SUBJECT: Final Case Closure
Tecumseh- Fill Area @ MW-1, 1604 Michigan Ave., New Holstein, WI
DNR BRRTS Activity #: 02-08-193776

FIGURE 1
SITE LAYOUT
EAST SECTION FILL AREA
TECUMSEH PRODUCTS COMPANY
1604 MICHIGAN AVENUE
NEW HOLSTEIN, WISCONSIN

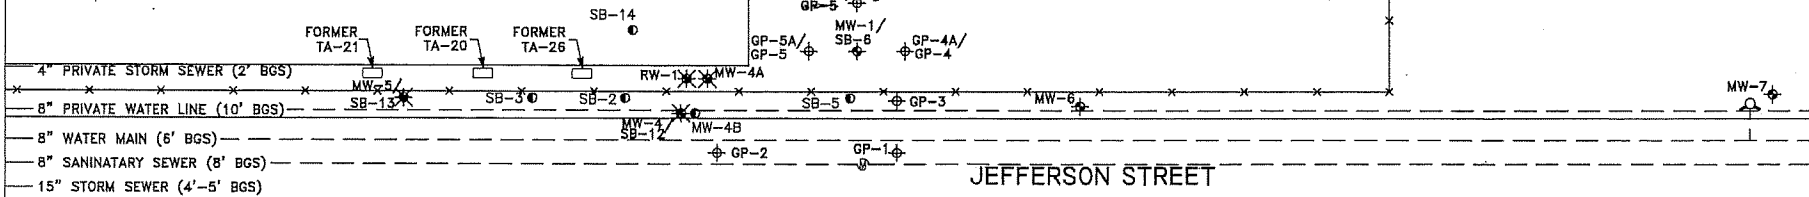
Some PCB contamination remains in the soil in the vicinity of soil sample location GP-6 (Figure 1, Site Layout, Key Environmental, May 1, 2003). If this soil is excavated in the future, the property owner or right-of-way holder at the time of excavation must determine if contamination remains. If contamination is present, the property owner or right-of-way holder at the time of

FIGURE 1
SITE LAYOUT
EAST SECTION FILL AREA
TECUMSEH PRODUCTS COMPANY
1604 MICHIGAN AVENUE
NEW HOLSTEIN, WISCONSIN

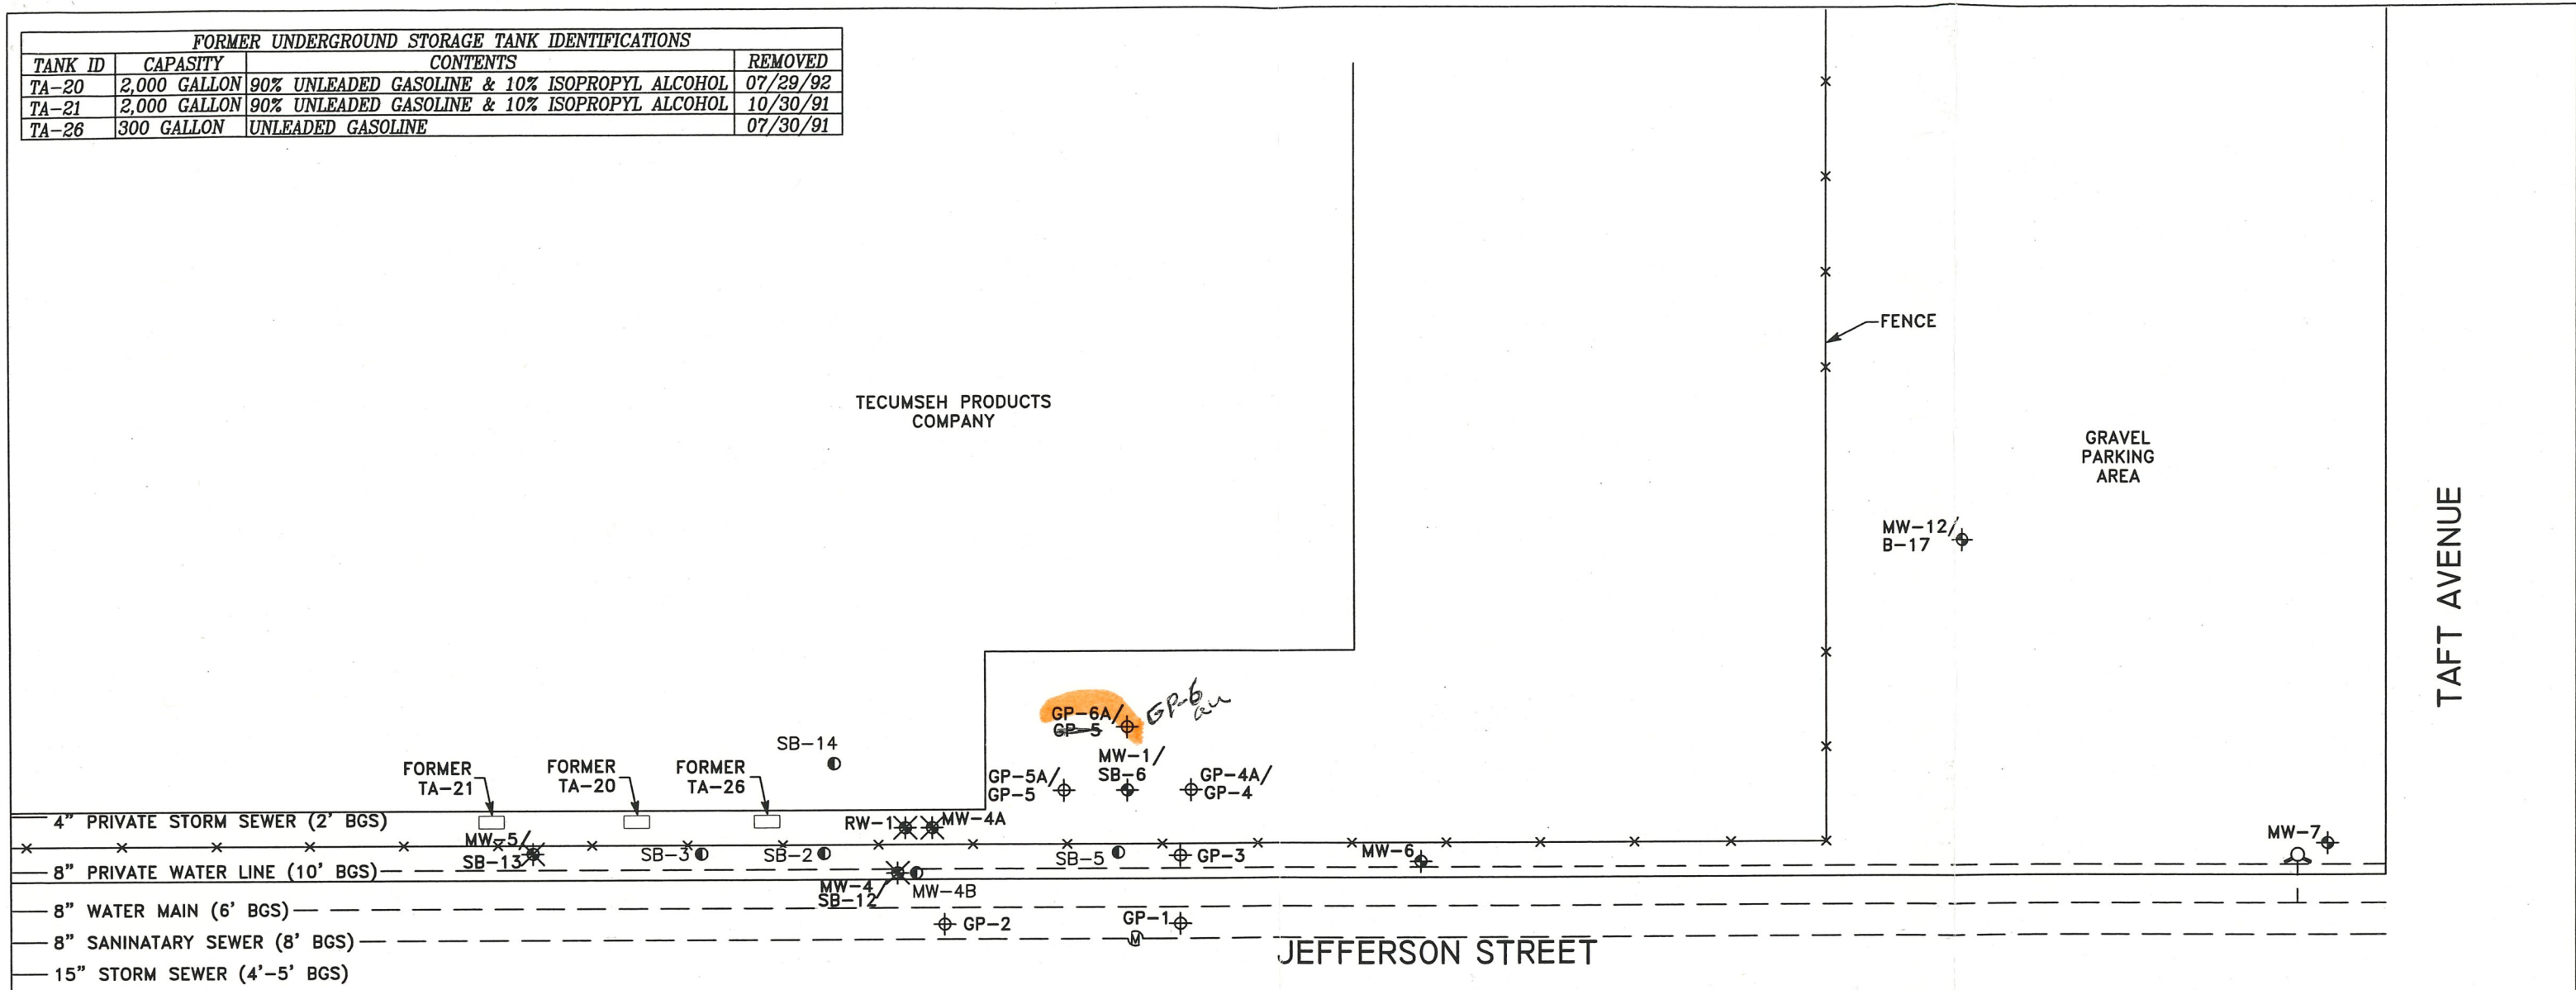
* Petroleum Contamination shown in Table 1 is related to another case (03-08-001070) Only soil contamination above standard on guidance is PCB @ GP-6A.
